PROJECT: North Castle NY - JG Petrucci DATE: 7/12/2021
 2179-99-009
 SUBJECT: 94 Business Park Drive TRANSMITTAL ID: 00006
 PURPOSE: For your use VIA: Info Exchange

**RE: Armonk Fairview, LLC &
Aggro and Brassi, LLC
Proposed Warehouse
Section 108.03; Block 1; Lot 50
94 Business Park Drive
Town of North Castle (Armonk)
Westchester County, NY
DEC #2179-99-009**

The following are responses to an engineering review letter prepared by Kellard Sessions dated March 5, 2021:

TITLE: **STORMWATER POLLUTION PREVENTION PLAN**

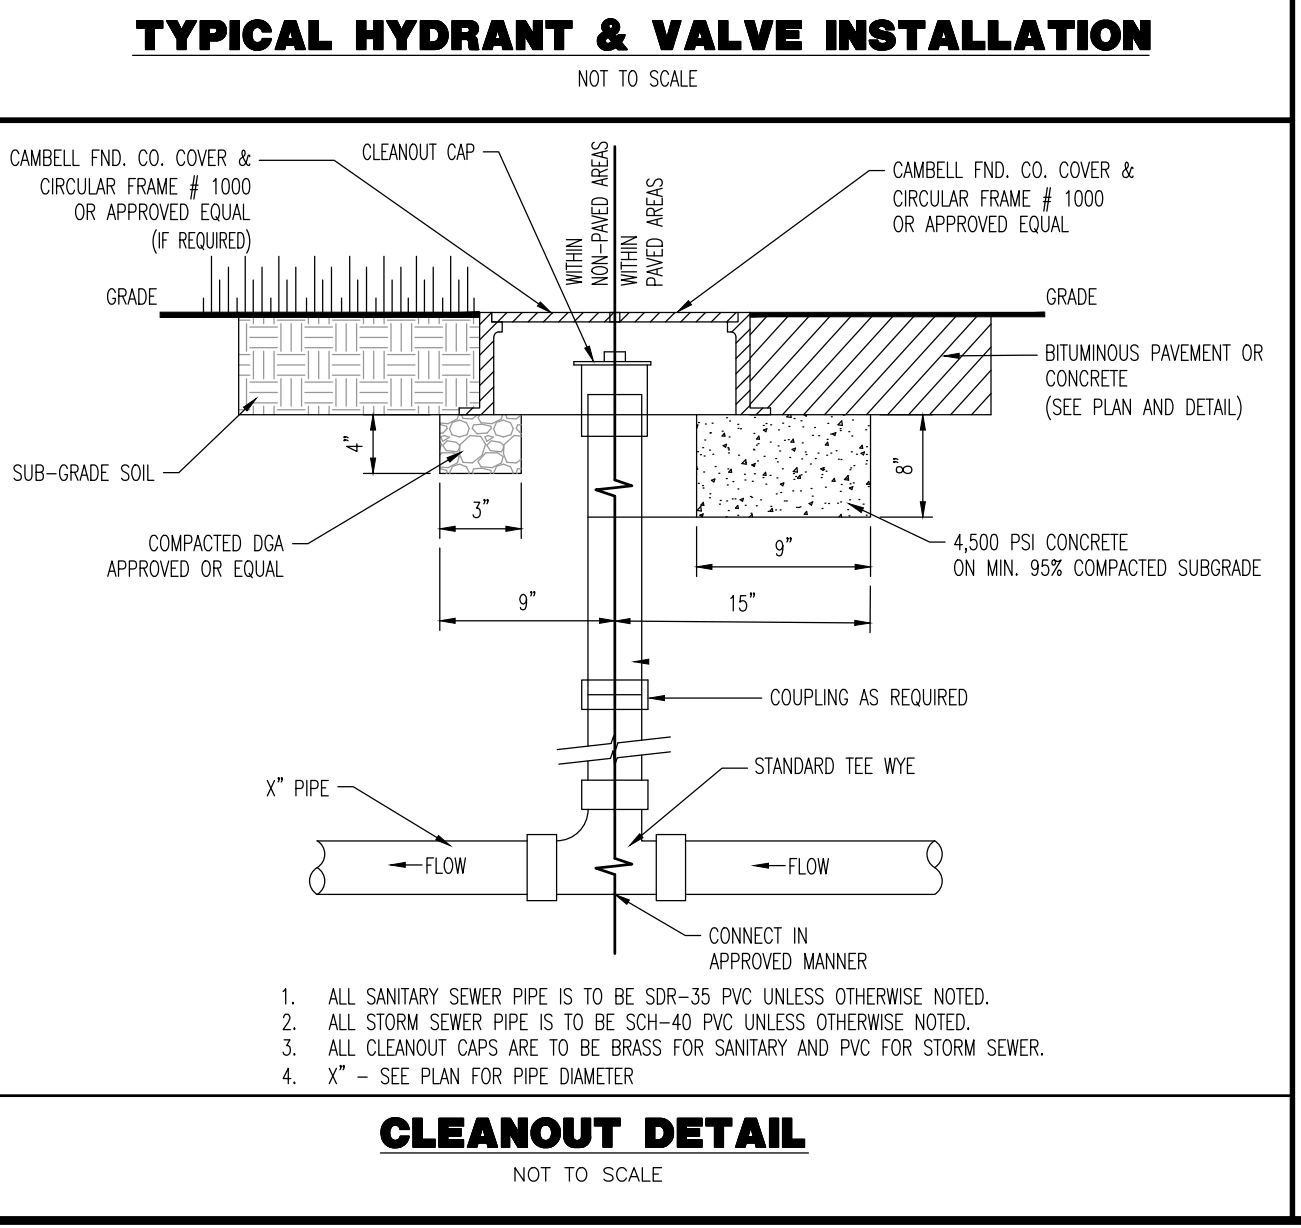
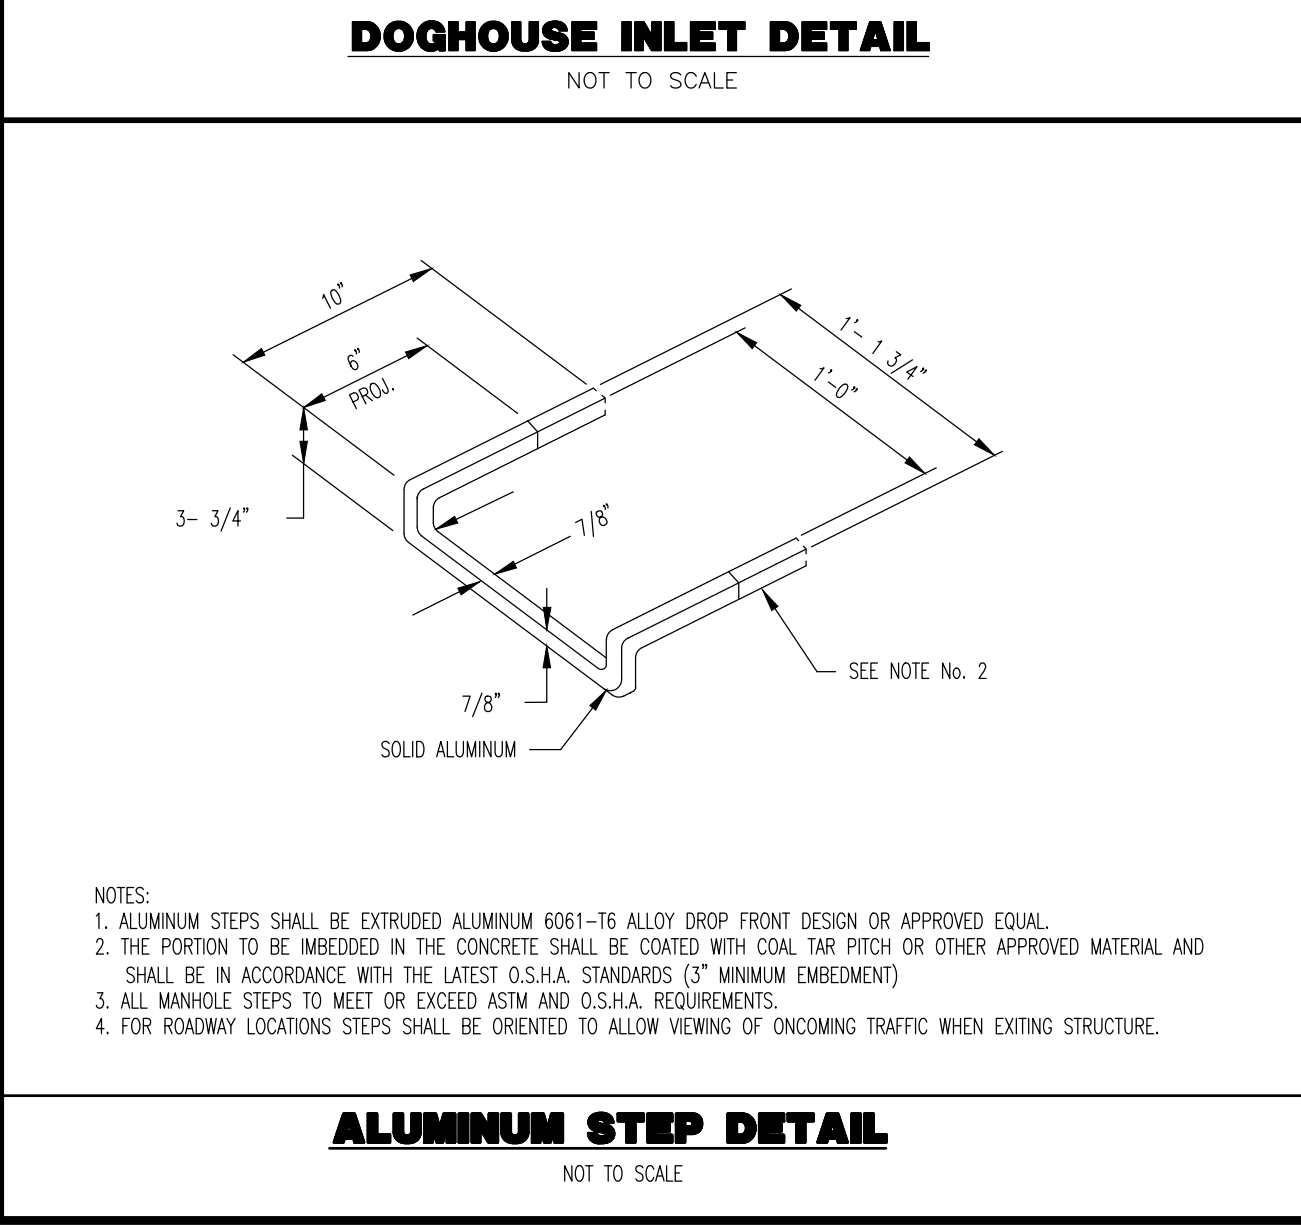
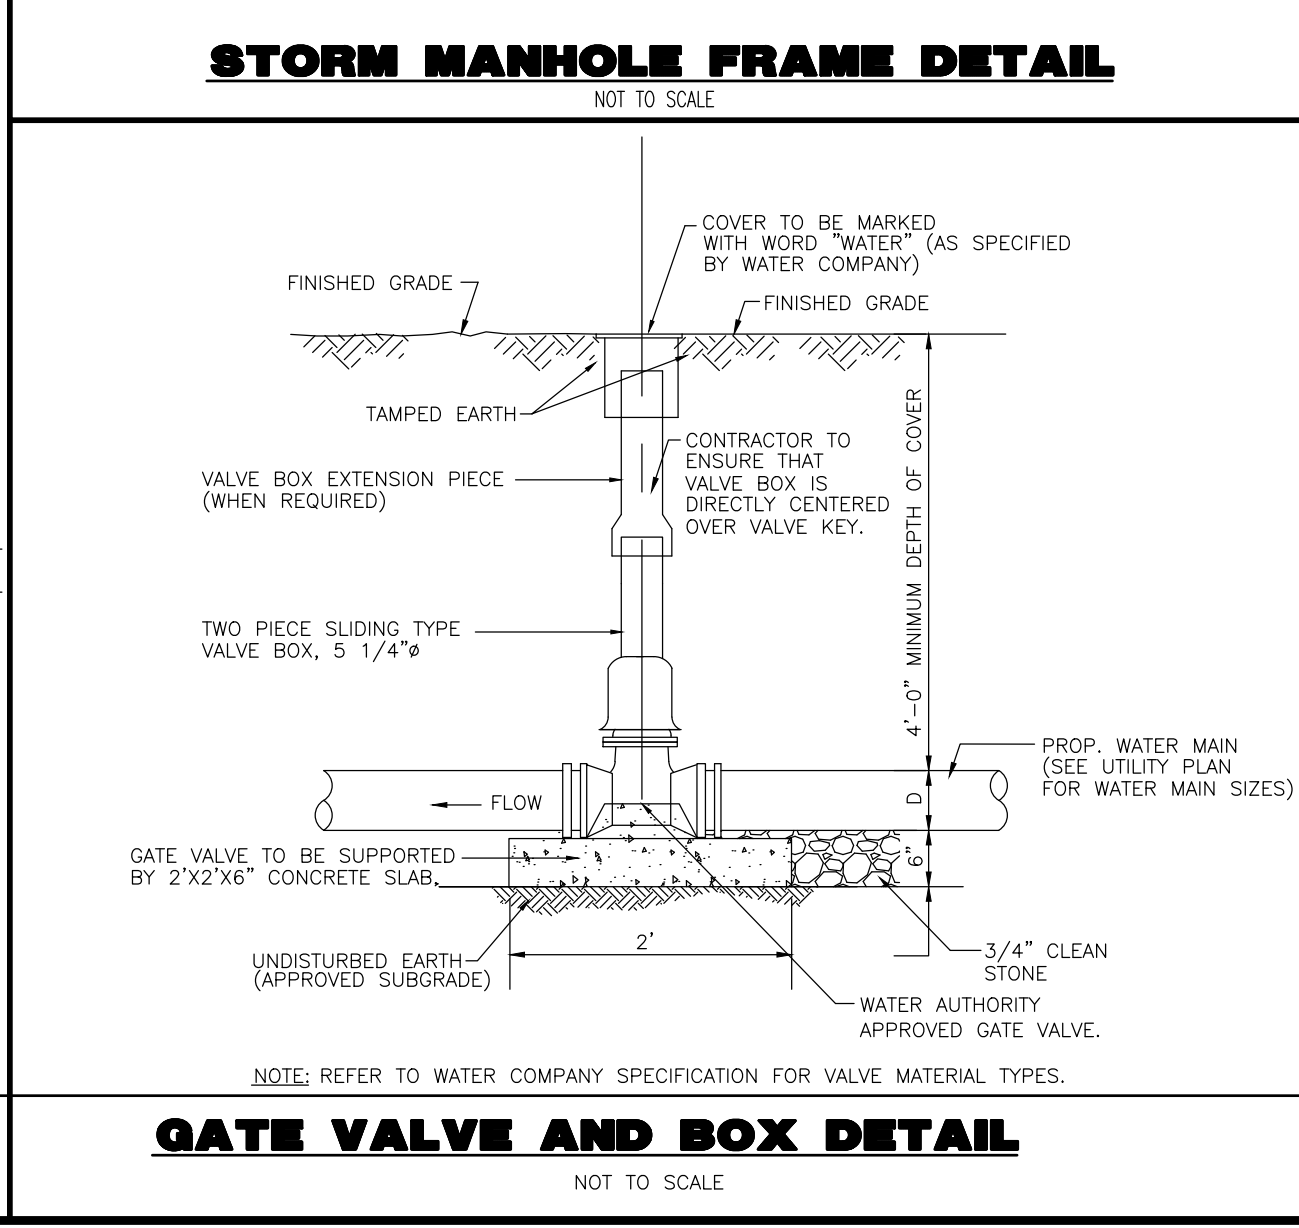
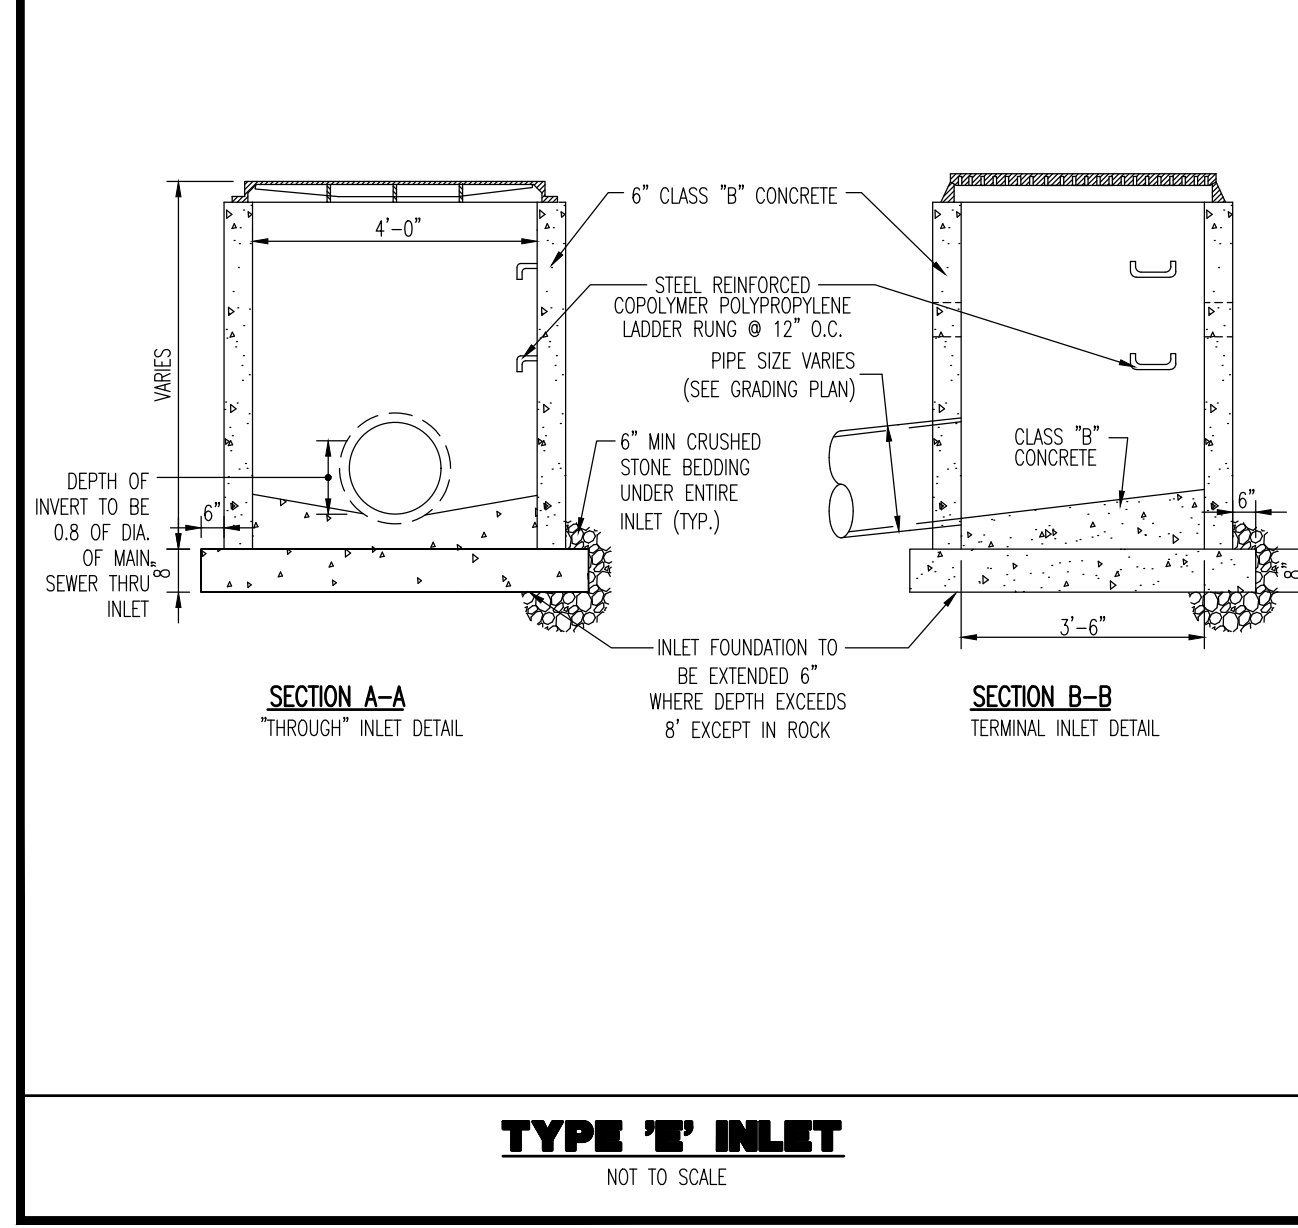
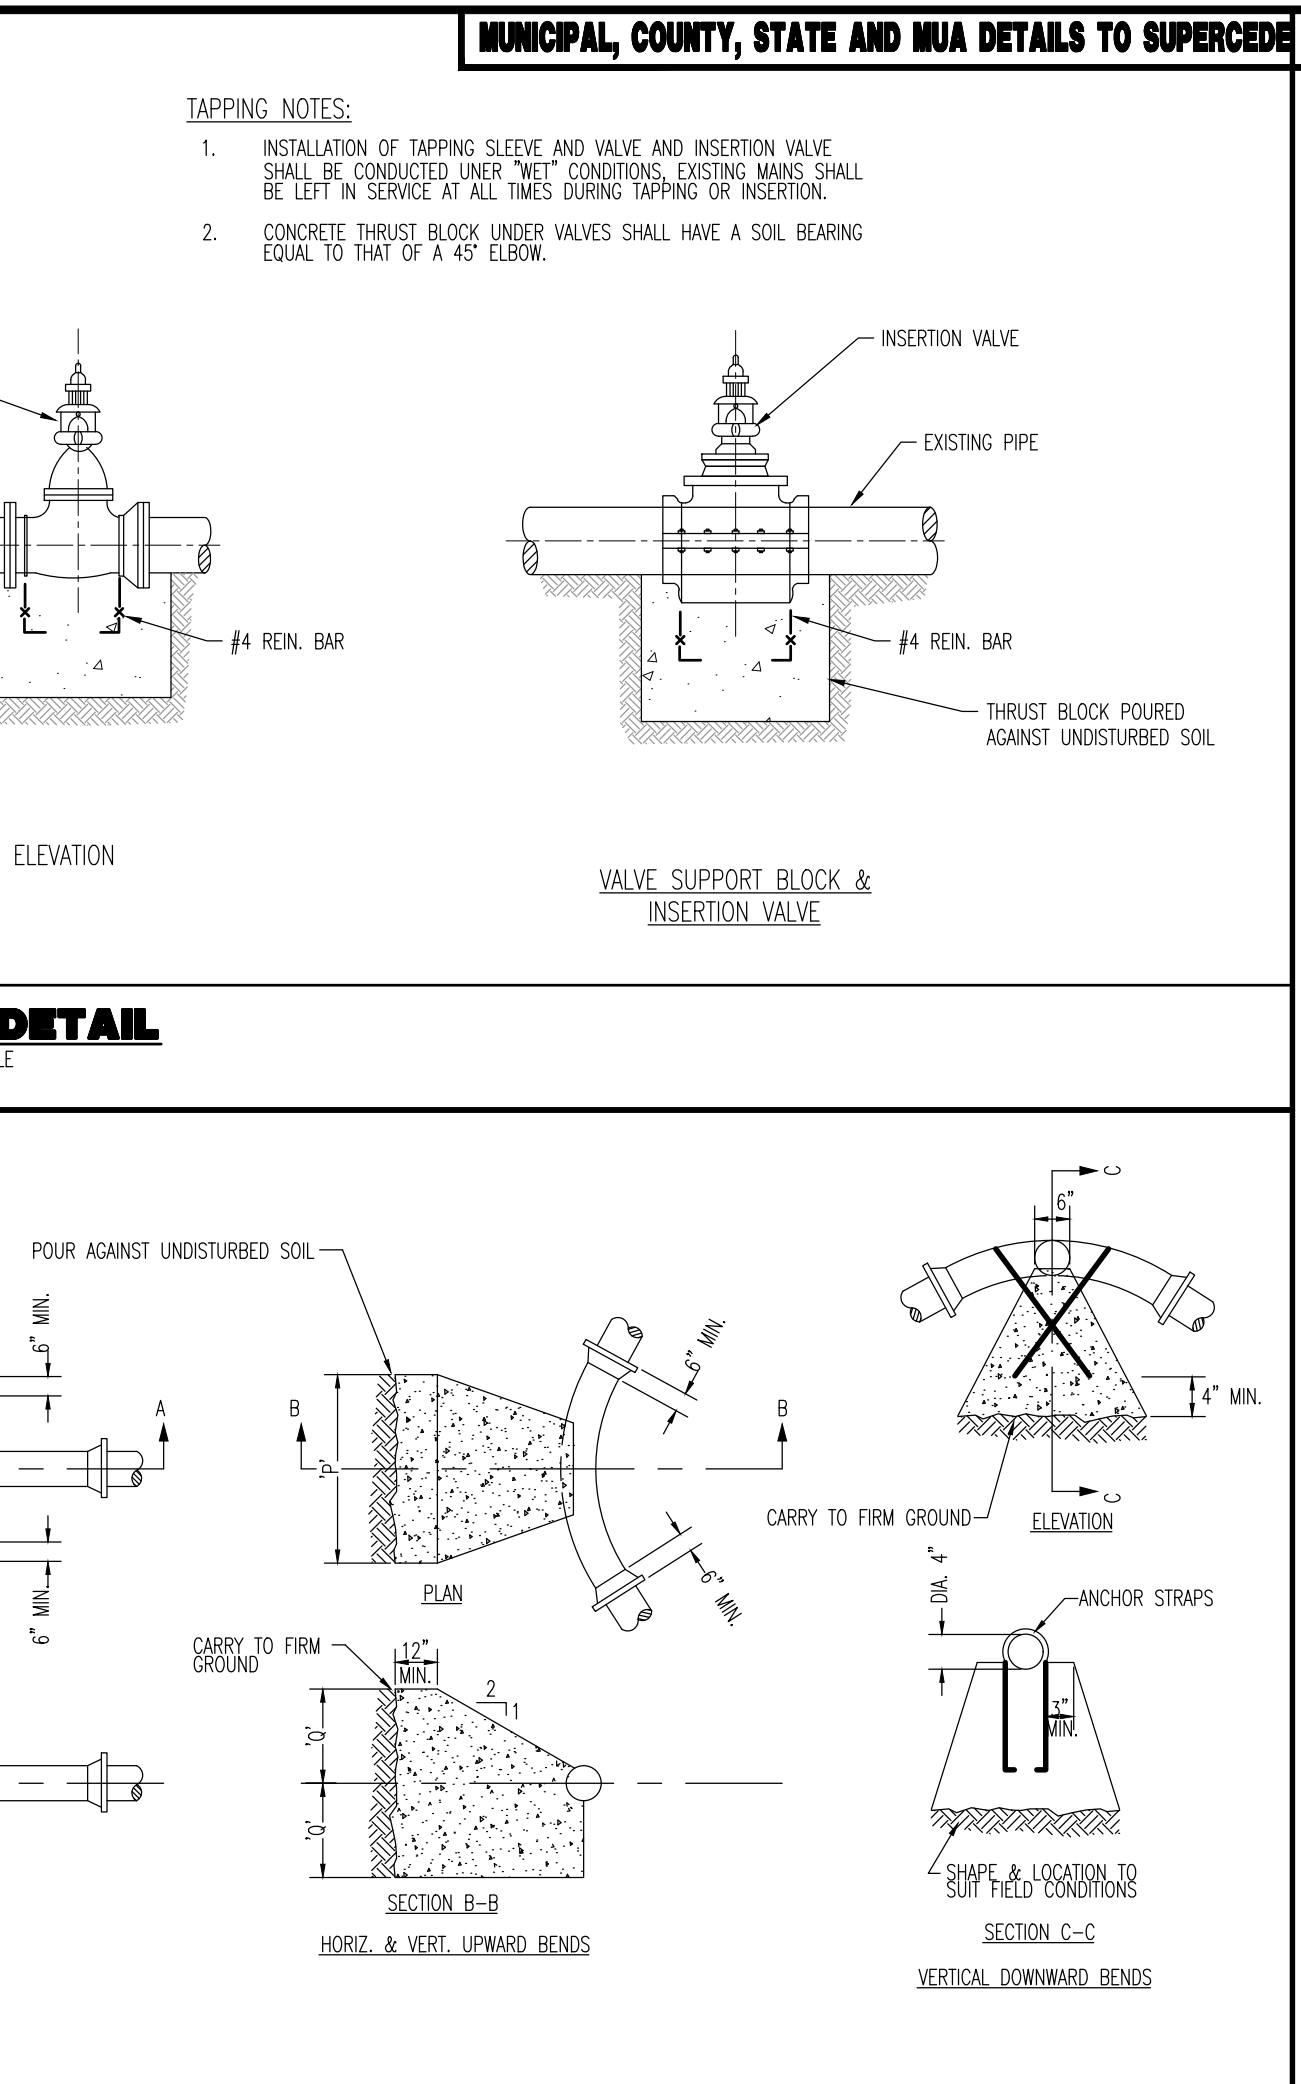
- l. The construction phasing and sequence described on the Stormwater Pollution Prevention Plan (Sheet 8 of 13) shall be expanded based on the phasing described above, as well to include provisions for temporary sediment basins, protection of drainage facilities throughout construction, conversion to allow stormwater mitigation systems to go on-line, wetland mitigation, etc.

The Stormwater Management report will be revised to include 100-year design flow following approval of the proposed water quality design.
